October 13, 1982

DOCKET 50-312
RANCHO SECO NUCLEAR GENERATING
STATION UNIT NO 1
NUREG 0737 ITEM II.B.3. POST ACCIDENT SAMPLING SYSTEM

ATTACHMENT NO. 1
POST ACCIDENT SAMPLING SYSTEM
NUREG-0737 ITEM II.B.3
DESCRIPTION OF COMPLIANCE

QA CAT II
POST ACCIDENT SAMPLING SYSTEM
FLOW DIAGRAM
 SACRAMENTO MUNICIPAL UTILITY DISTRICT
 RANCHO SECO

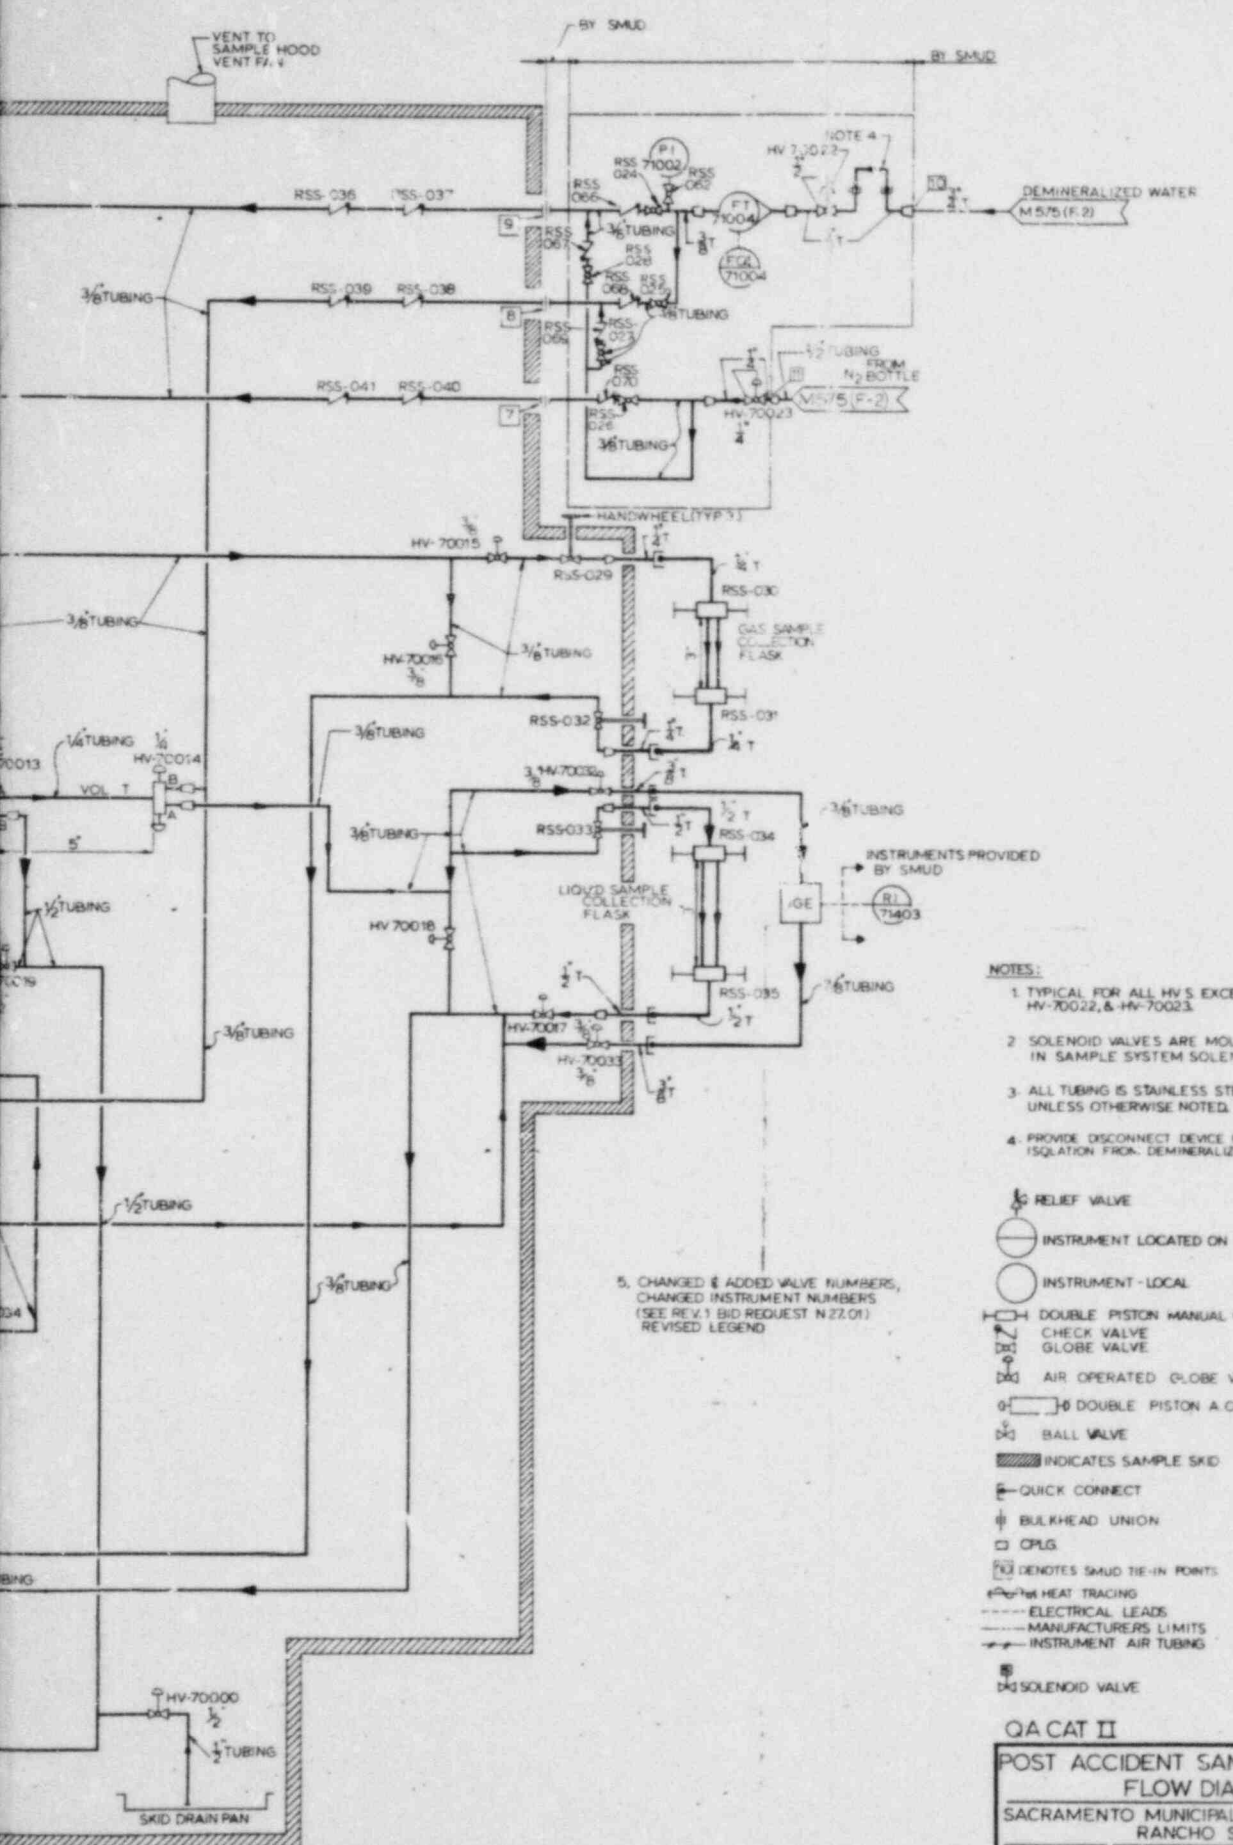
- ITEM NO. 3 : System schematics and discussions should clearly demonstrate that post accident sampling, including recirculation, from each sample source is possible without use of an isolated auxiliary system. It should be verified that valves which are not accessible after an accident are environmentally qualified for the conditions in which they must operate.

- Response : As shown in the attached drawings, an isolated system, e.g., the pressurizer sample line, will be used. The safety feature's valves are controlled from the control room, thereby providing positive operator control. This line was used because it provides the desired containment penetration; is of small size, 3/4 inch; and does not carry fluid outside of the decay heat cooler rooms, a high radiation area.
